**DATE:** 06.30.2016  
**TO:** ProTrak  
**FROM:** Bill McDow  
Transportation Planning

**■ OGDEN MARKETPLACE- LANDSCAPE [TRC Plan Review #4]**

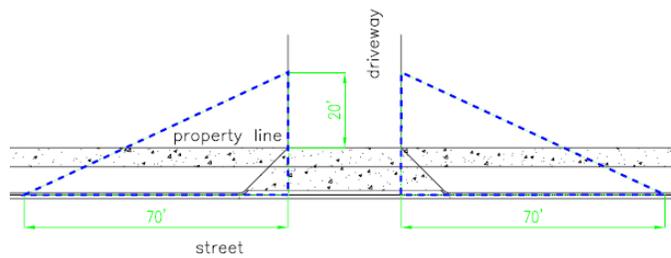
- The Right of Way line on Middle Sound Loop Road is shown partially within the right turn lane on Middle Sound Loop Road. The ROW must be outside of a street or highway travel lane. Redraw the ROW or dedicate additional ROW to get the line out of the street.
